STANDARD DEPARTURE CHART-INSTRUMENT

RJFN / NYUTABARU

INSTRUMENT APPROACH CHART

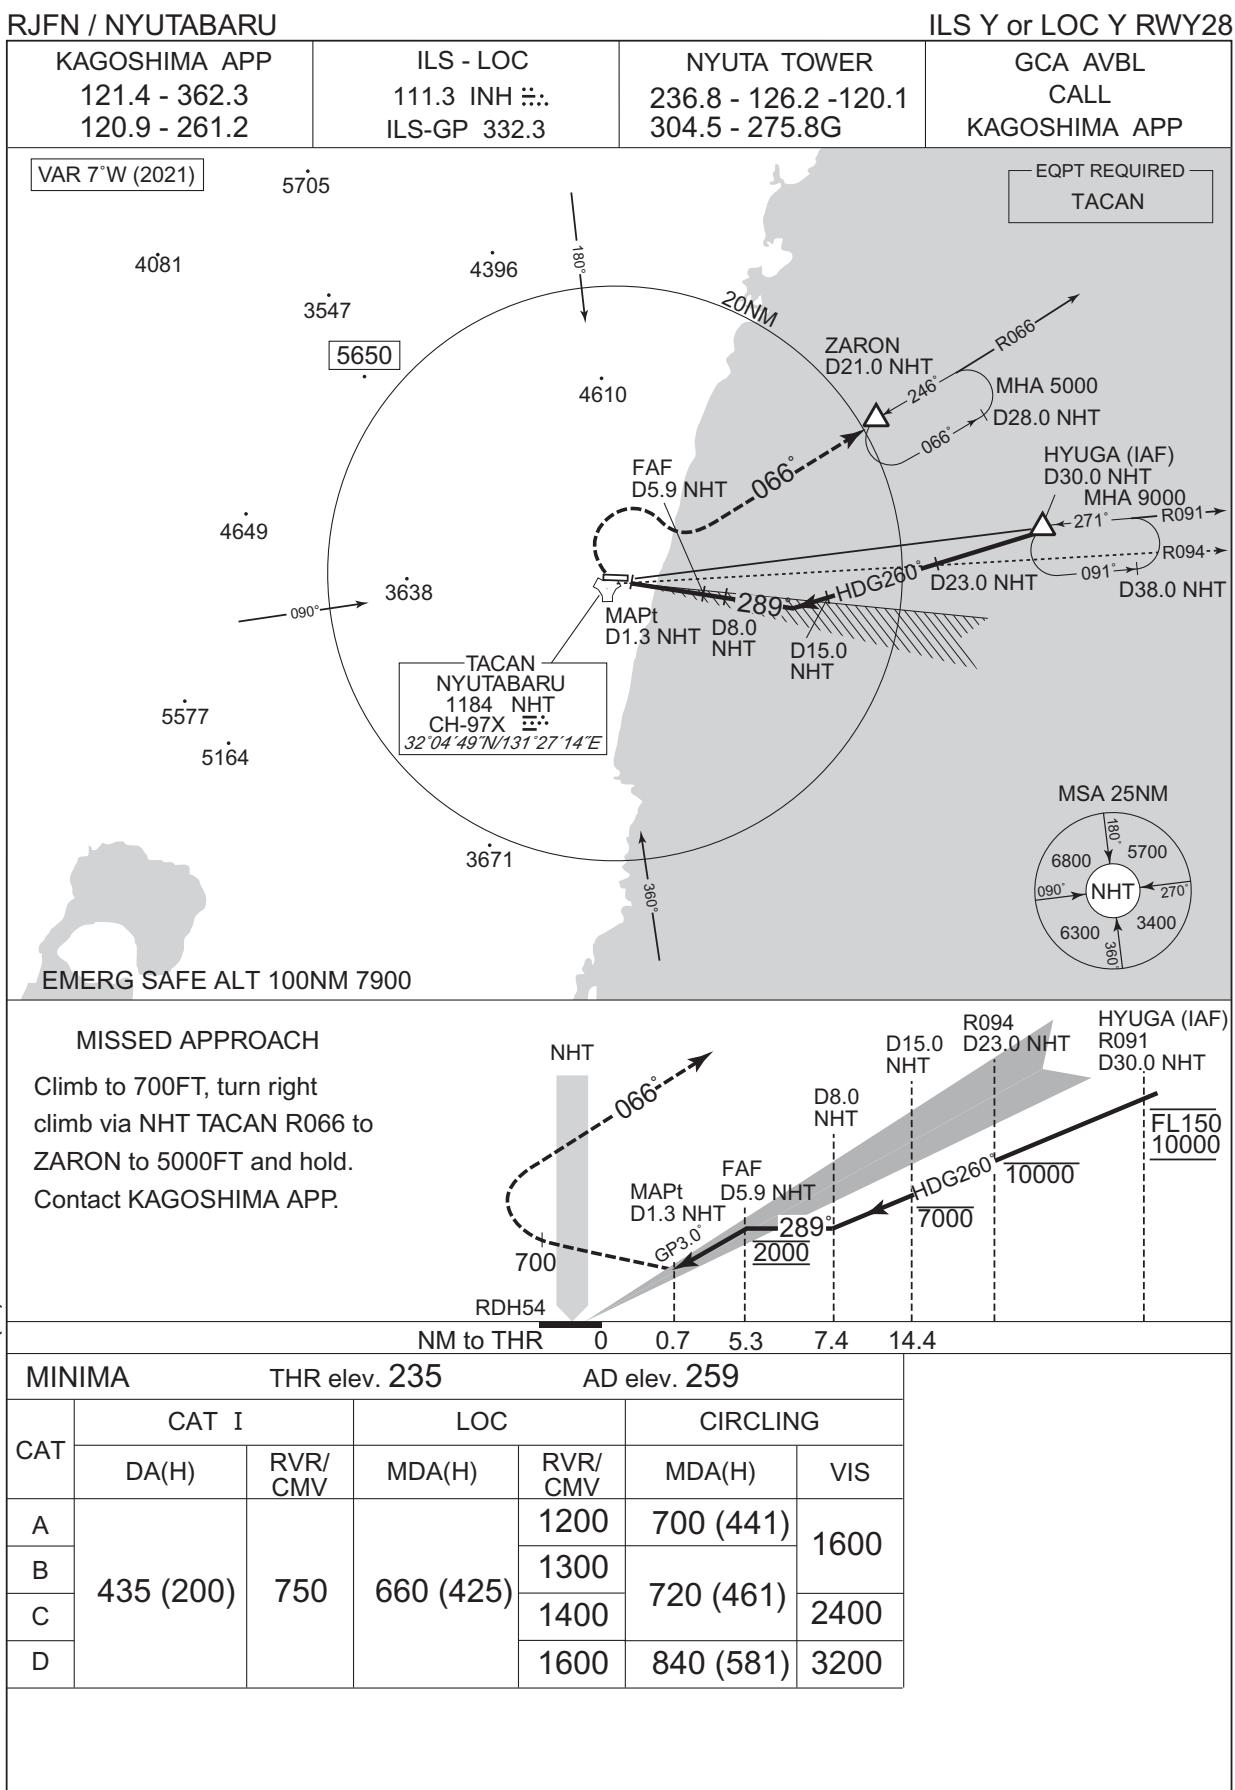
CHANGE : VAR, PROC renamed. EQPT REQUIRED added. PROC course. MISSED APPROACH course. MSA.
NM to THR added. MDA(H) for CIRCLING.
